Addendum No.: 4

Date of Addendum: June 17, 2020

Willard Diloreto Parking Garage
Paul Manafort Sr. Drive
New Britain, CT
CF – RC – 402

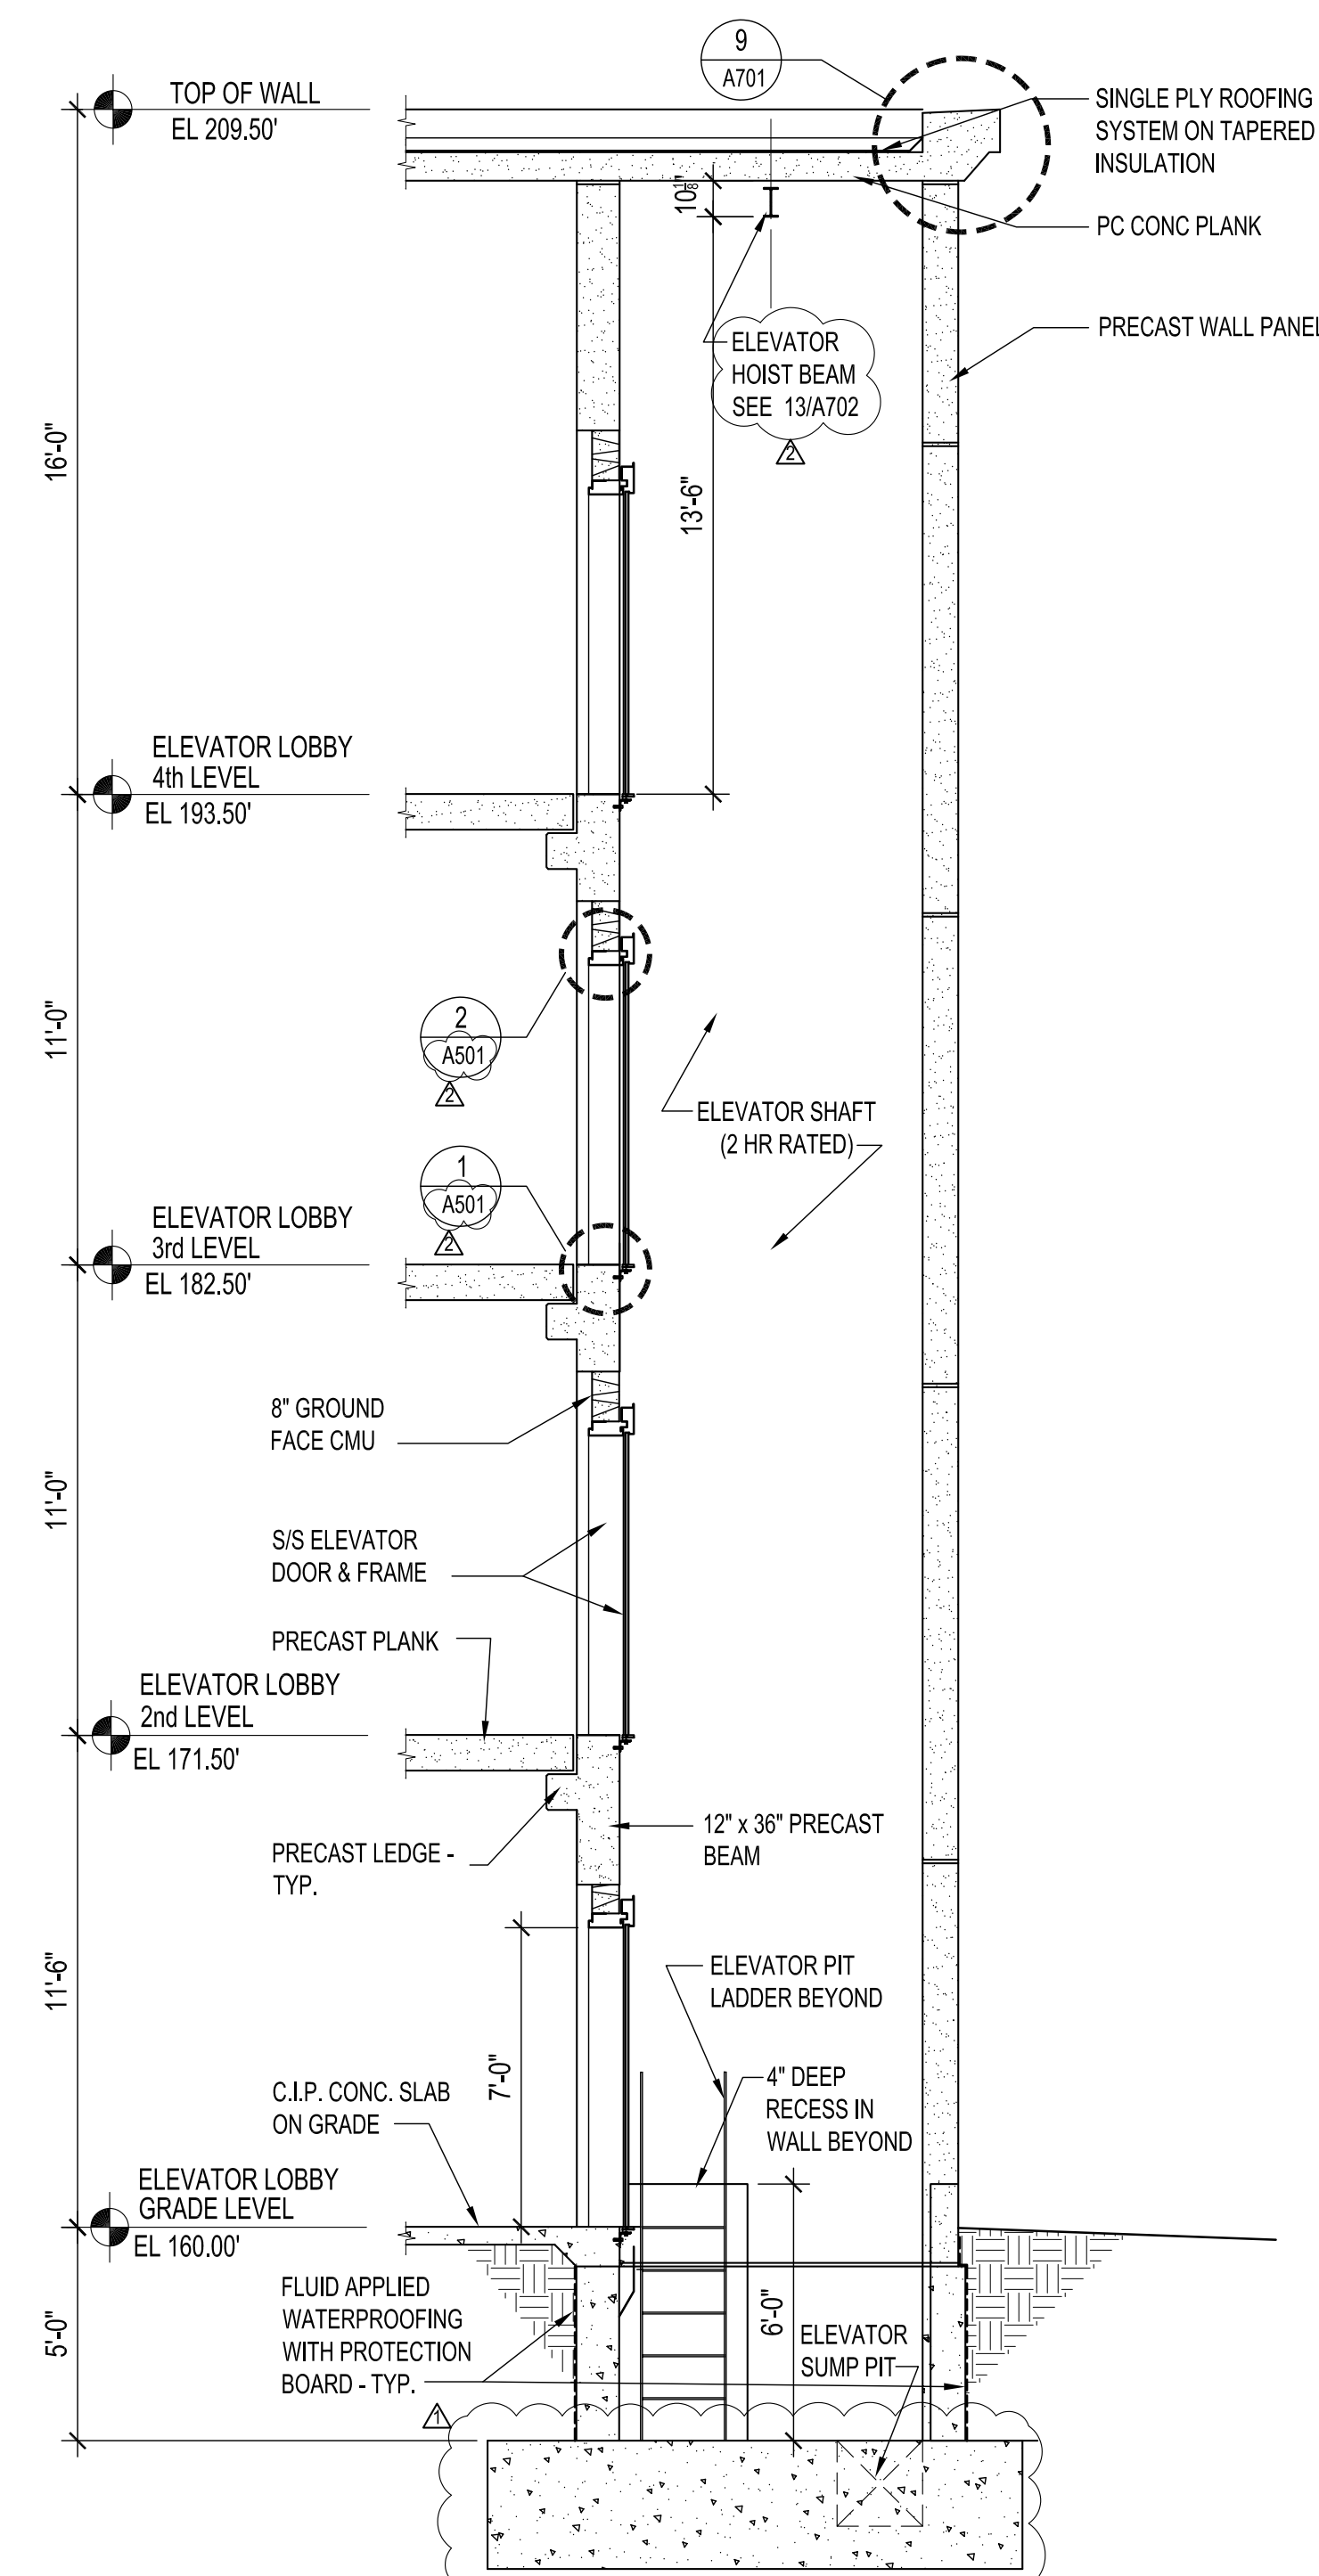
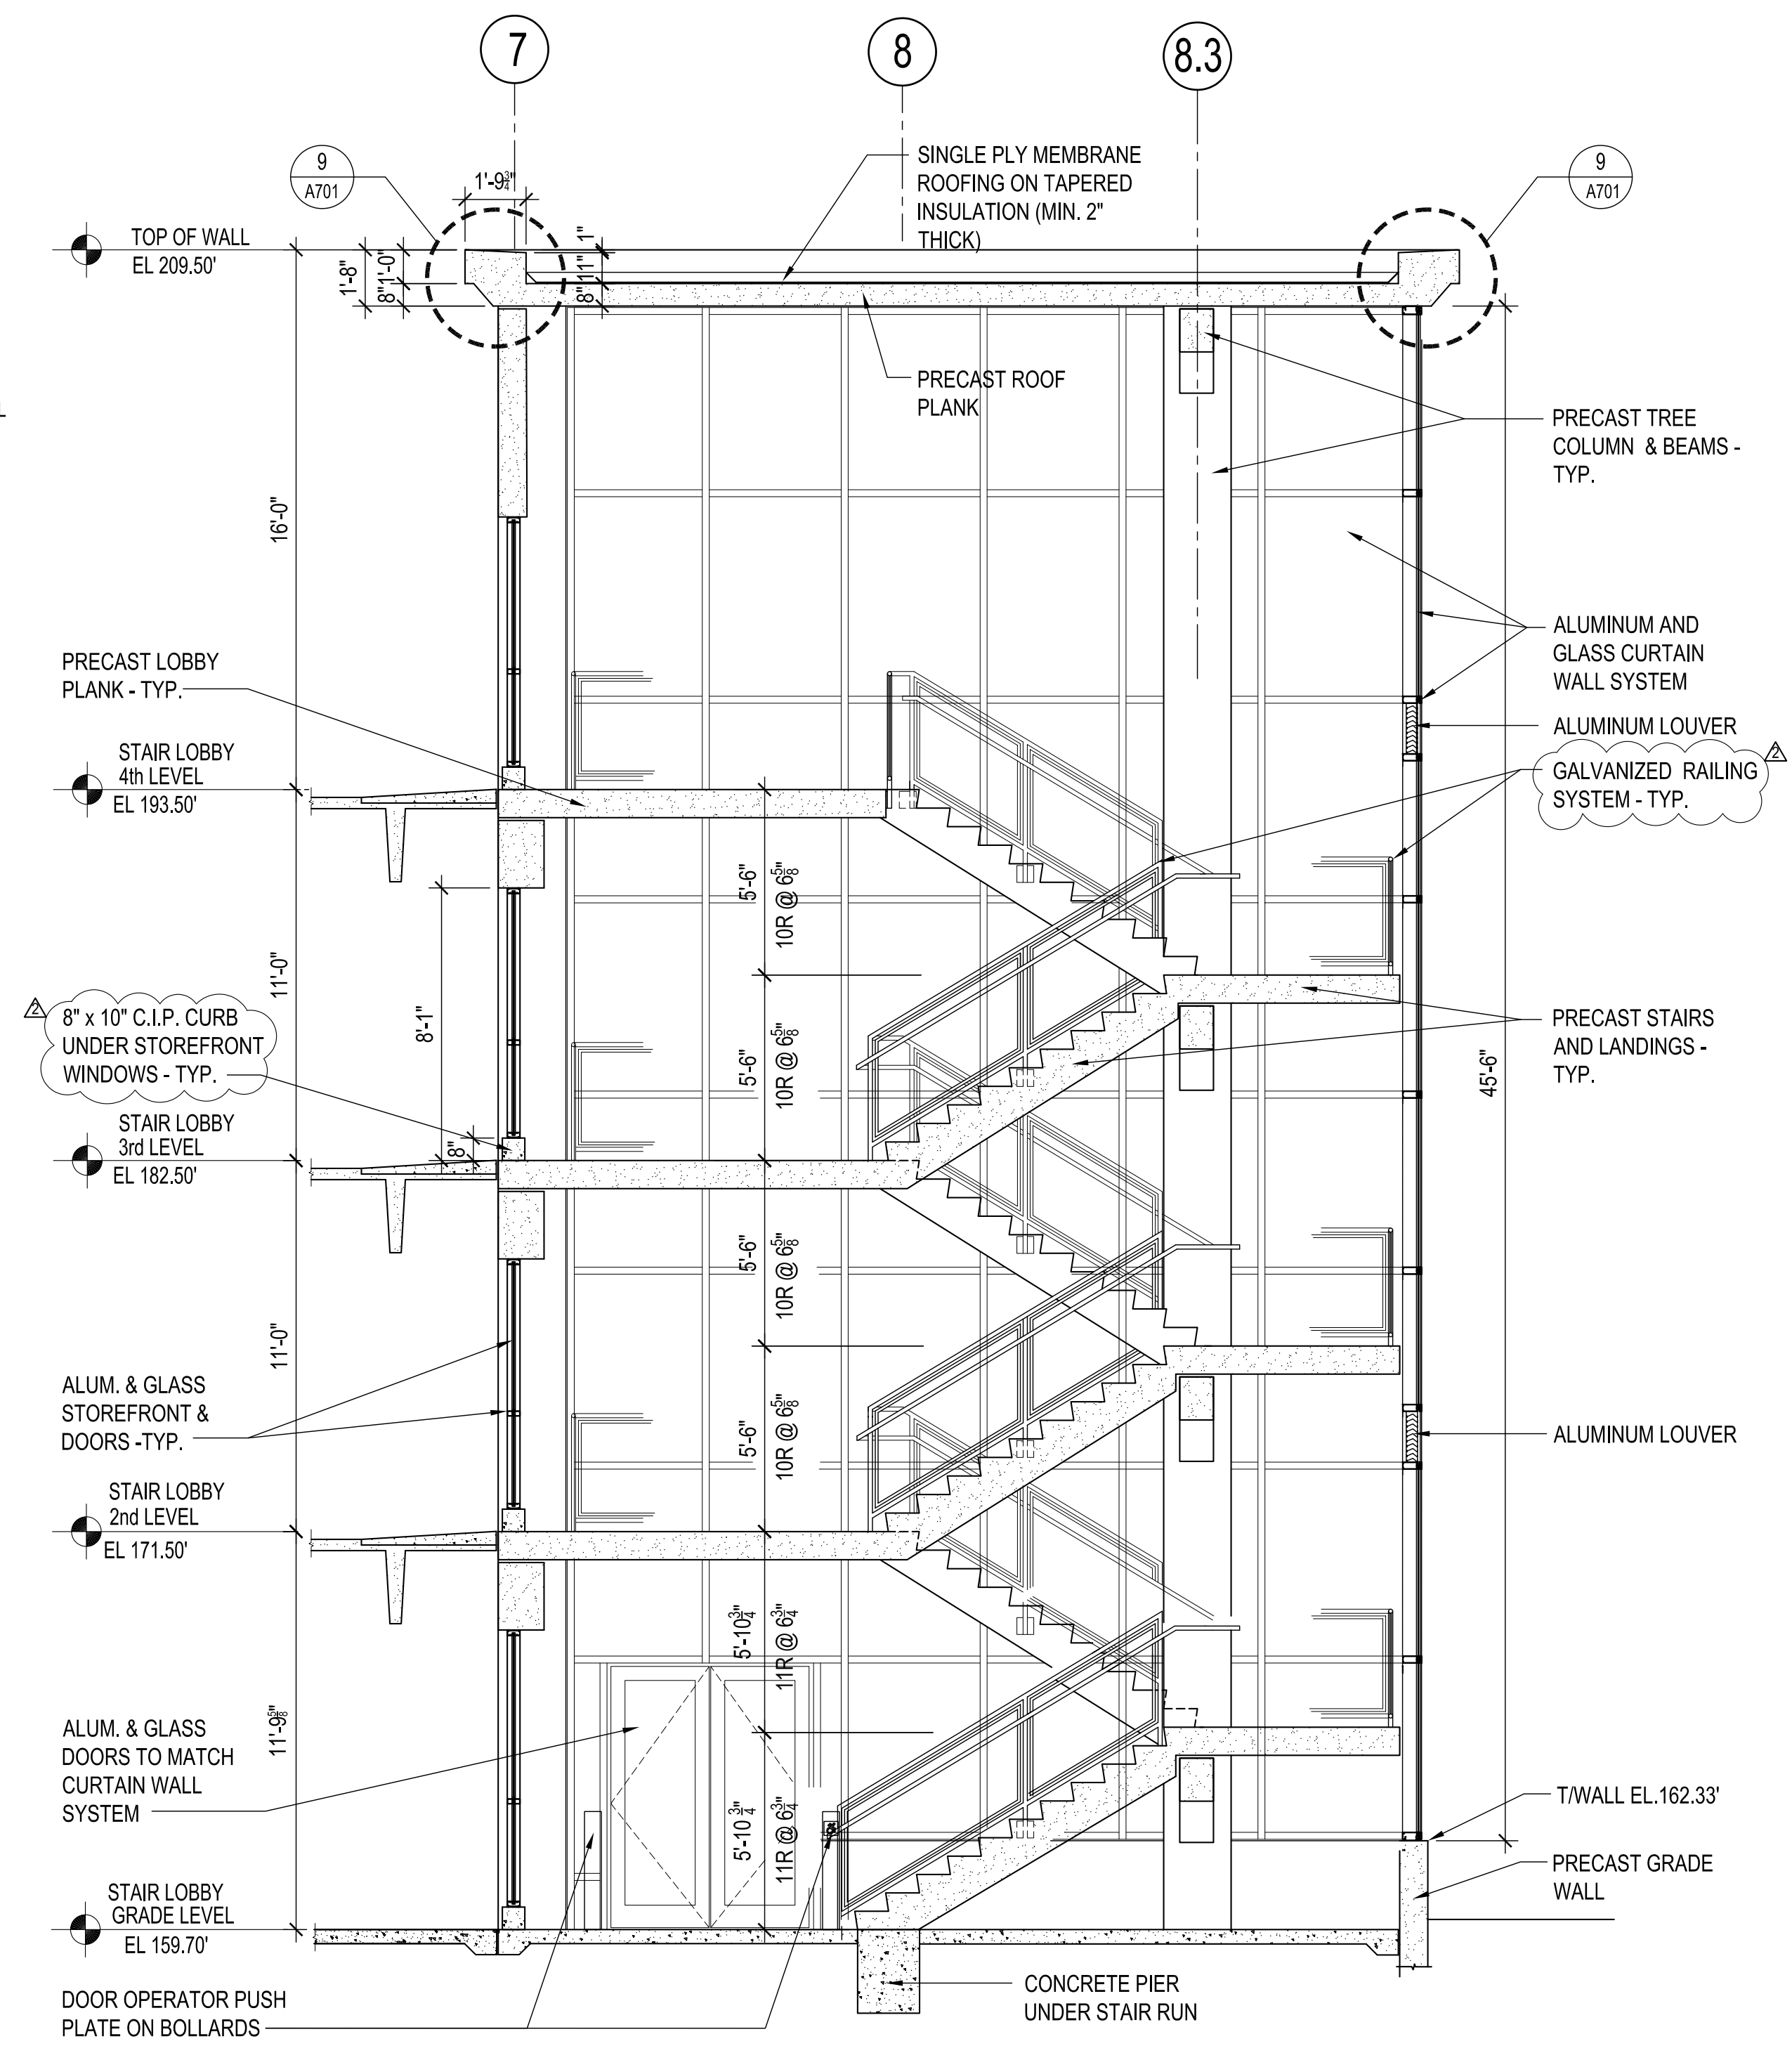
Question: Stainless Steel vs Galvanized Finish (A703) vs Field Painted Finish (2/A405)- are in conflict between building cross sections, enlarged plans and details. Please confirm design intention of Handrails and Guardrails in the stair towers for base bid, as well as (Alternate) Supplemental Bid (A703 & Spec 012313).

Answer: Base bid: All guardrails frames, screens, posts, etc. to be galvanized and not painted for the Base Bid. All handrails are to be stainless steel for the Base Bid. The Alternate (Supplemental Bid) calls for a color galvanizing coating on the guardrails.
